From: Kouretas, Malgorzata E CIV USARMY ARDEC (US)
To: [Lawyer, Dennis](#)
Cc: [Krasnow, Nicholas D Jr CIV USARMY \(US\)](#)
Subject: [External_Sender] RE: RE: Department of the Army, Request for Additional Information Concerning Application for a License Amendment, Control 601500, Lic. No. SUB-348, Docket No. 04006377
Date: Wednesday, January 03, 2018 2:39:47 PM
Attachments: [Response to NRC RAI 14 Dec 2017.pdf](#)

This is in reference to your letter dated October 24, 2017, requesting for approval of a survey plan and an amendment to Nuclear Regulatory Commission License No. SUB-348, Docket No. 04006377. In order to continue our review, we need the following additional information:

**SUBJECT: Response to Request for Additional Information dated 14 Dec 2017,
Control 601500, License No. SUB-348**

Screening Level DCGLs for the Stated Radionuclides

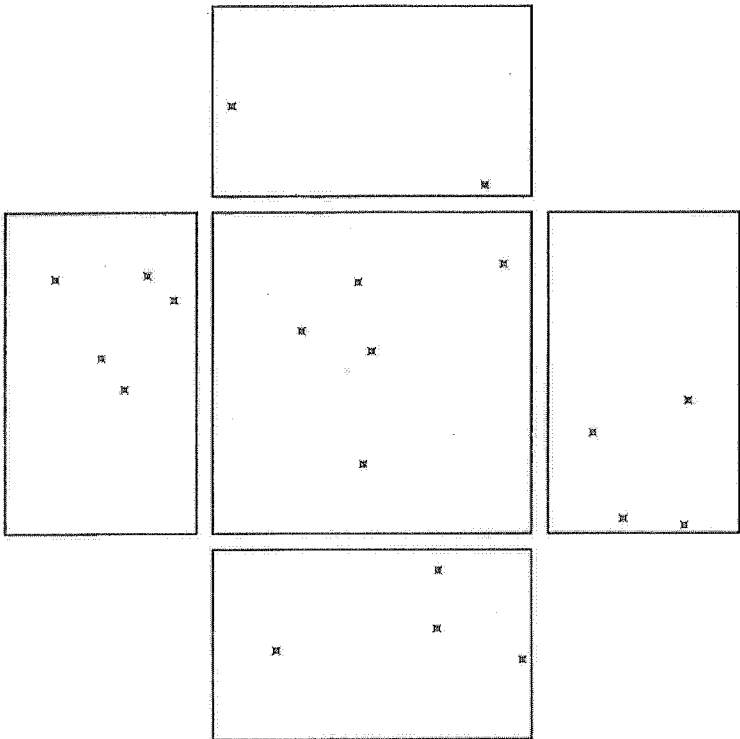
3. In section 3.3, you state that you calculated the Derived Concentration Guideline Level (DCGL) as 2,240 disintegrations per minute/100 square centimeters utilizing DandD, Version 2.1. Please submit a copy of that calculation.

3. The calculated screening level DCGL for U-238 (including use of the revised resuspension factor of $1\text{E-}6\text{ m-1}$) is $1400\text{ dpm}/100\text{ cm}^2$ and if using surveys for gross alpha emissions as the primary method of demonstrating compliance, this DCGL would be applicable. However, since the plan is to use beta emissions as the primary method of demonstrating compliance and the alpha to beta ratio for depleted uranium is 1:1.6 (NUREG 1757, Appendix O, Section O.3.3.5), the $2,240\text{ dpm}/100\text{ cm}^2$ should be used as the screening level DCGL for depleted uranium. A copy of the D&D output summary report will be provided. In the meantime, attached is a table which shows DCGLs calculated using the revised resuspension factor guidance from the NUREG.
